Subject: Reply to Request for Additional Information (TAC L33190)

ENCLOSURE 1
Reply to Request for Additional Information

The following questions were requested regarding B&W NOG's Amendment request to Chapter 9 (TAC L33190).

ENCLOSURE 2
Sanitary Wastewater System

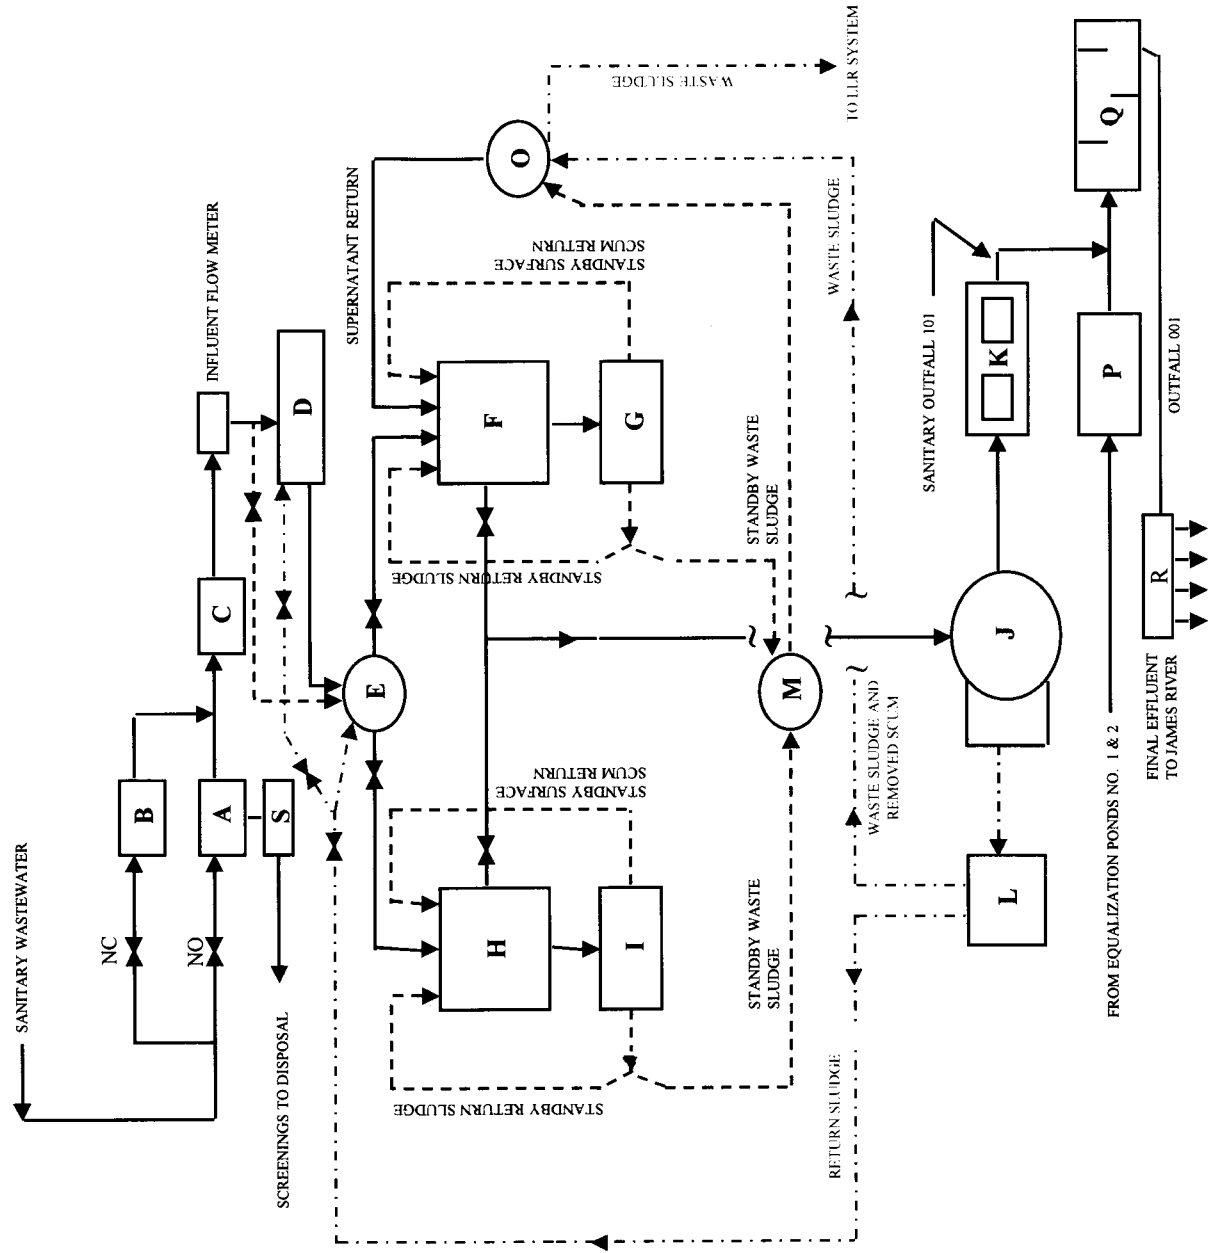
Please provide process descriptions (waste type and origin) and a brief description in the text of proposed paragraph 9.6.4, which ensures that the "...industrial or other waste treatment processes..." are not connected to the radioactive processes, and assurances that any new processes would be subject to the review and record keeping required by 10 CFR 70.72

The system is an activated sludge process. In the aeration tanks, microorganisms are mixed with the organic-laden wastewater. As the microorganisms grow, they clump together (flocculate) to form an active mass of microbial floc called activated sludge. Wastewater in the aeration tanks (or mixed liquor) is pumped into a clarifier for settling. In the clarifier, aggregated or flocculated solids, settle to the bottom of the tank and form a layer of concentrated sludge. Most of this sludge, (return sludge) is pumped back into the aeration tanks to facilitate the breakdown of organics. However, since the bacteria are constantly growing, some of the sludge eventually has to be removed from the system. Small amounts of sludge, referred to as waste sludge, are removed from the clarifier to a Sanitary Sludge Holding Tank (SSHT) for eventual disposal. A diagram of the Sanitary Treatment System is provided as Enclosure 2.

The sanitary treatment system consists of a mechanical bar screen, a screenings screw compactor, two lift pumps, a sock filter, a flow equalization tank, a flow splitter box, two aeration tanks, a sanitary circular clarifier, an ultraviolet disinfection system, a return/waste sludge pumping station, a sanitary sludge holding tank, and a mixing chamber.

Raw wastewater flows through the mechanical bar screen, removing floating and suspended materials, which are discharged to a screenings screw compactor, which de-waters, compacts and conveys screened solids to a drum for disposal as Rake Solids.

The wastewater is pumped through a flow meter and a sock filter, into the flow equalization tank. The wastewater is pumped into a splitter box, mixing the wastewater with return activated sludge (RAS) and then to the aeration tanks.

The mixed liquor flows to the clarifier. Most solids settle to the bottom. Floating solids and scum are scraped from the surface by a skimmer arm. The scum may be mixed with the RAS and routed to the secondary treatment process, or to the Sanitary Sludge Holding Tank (SSHT). Clear water flows to the Ultraviolet (UV) disinfection unit.

Sludge is scraped to the center sludge sump. Most sludge is pumped back to the splitter box as RAS. Periodically, sludge is pumped to the SSHT.

The SSHT has a gravity overflow that returns supernatant to the aeration tanks. Clarifier effluent flows to the UV unit.

Sanitary wastewater flow from the UV system to a mixing chamber combining with treated wastewaters. The effluent is discharged to the James River via a diffuser.
